Historic Architectural Review Commission
Staff Report for Item 7

Application Number: H18-03-0035

Address: #409 Margaret Street

New one-story rear ~~addition~~ deck cover.

REVISED DESIGN

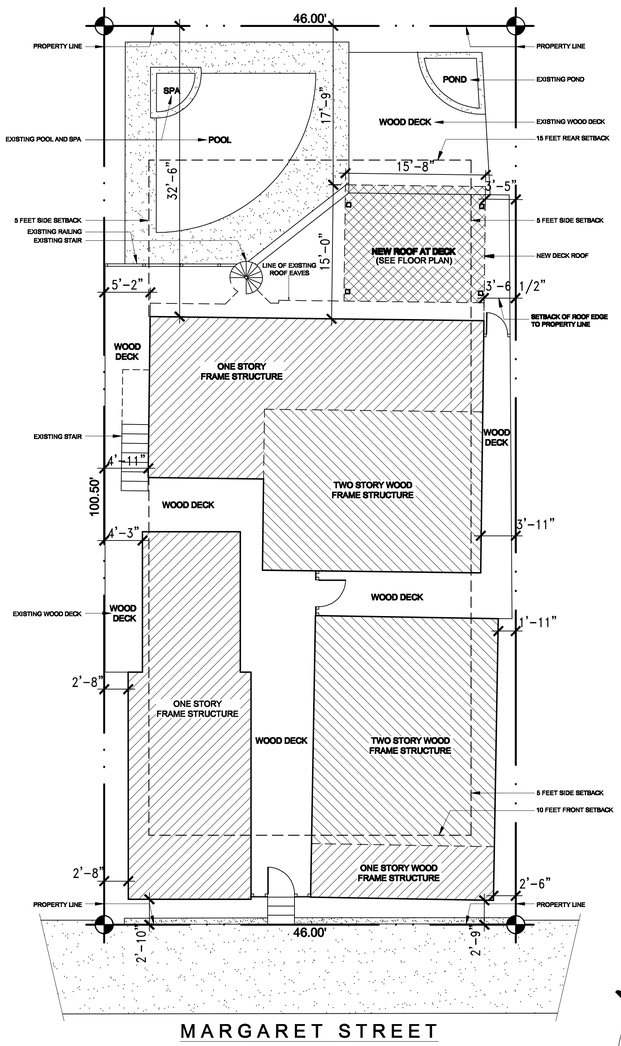
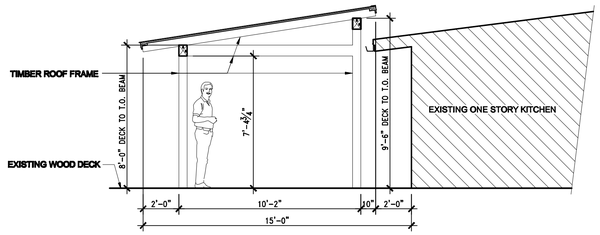
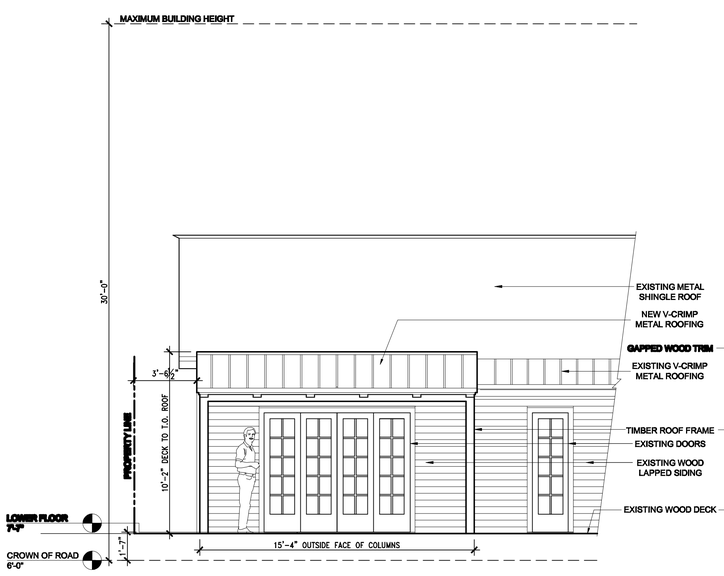
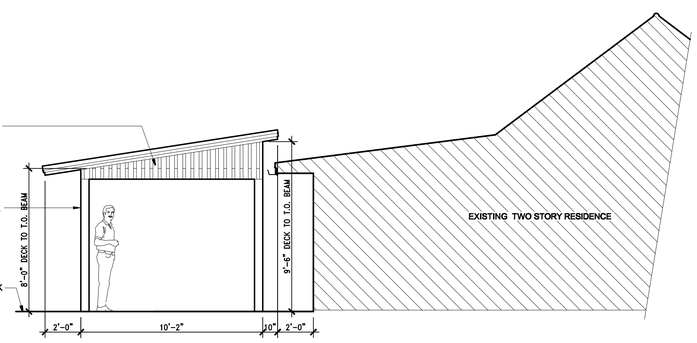
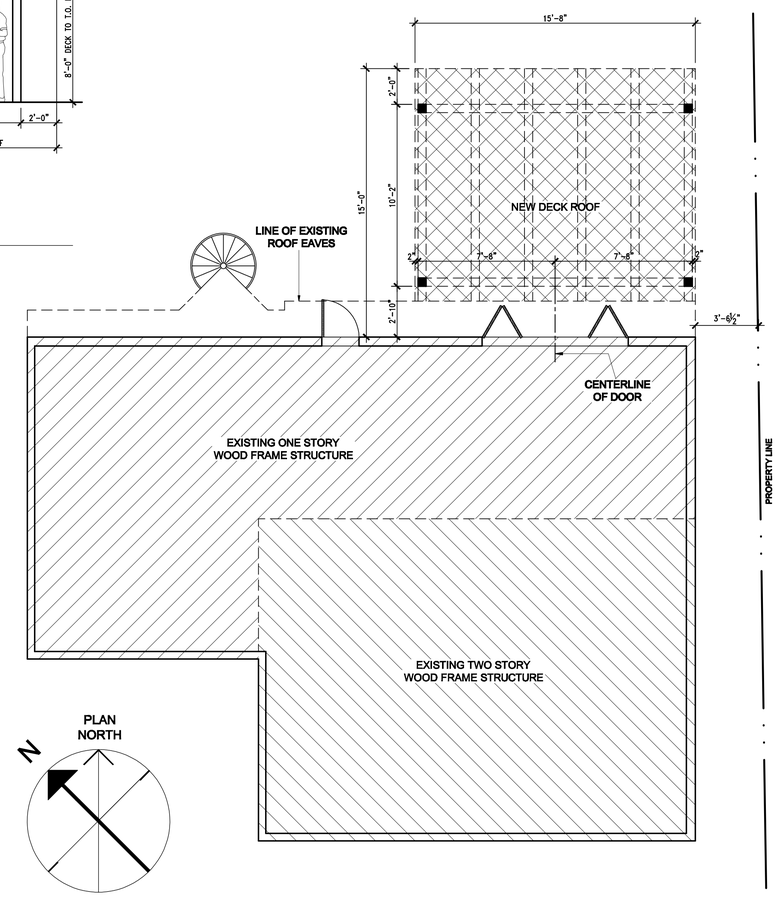
This report is for revised plans that now propose a detached structure to cover a rear deck. The new design proposes a shed roof structure slightly taller than the rear portion of the

house in question. The new proposed accessory structure will be one-story frame with a shed roof extending on its maximum height approximately 10' from the existing deck. The structure will be rectangular in footprint and will be covered with metal v-crimp roofing.

It is staff's opinion that the proposed design is consistent with the cited guidelines. The new accessory structure will slightly taller than the rear portion of the main house but will not have any effect on the main house or its historic context. The proposed roof form and scale of the structure is harmonious and similar to the building forms found in the historic house and surrounding context.
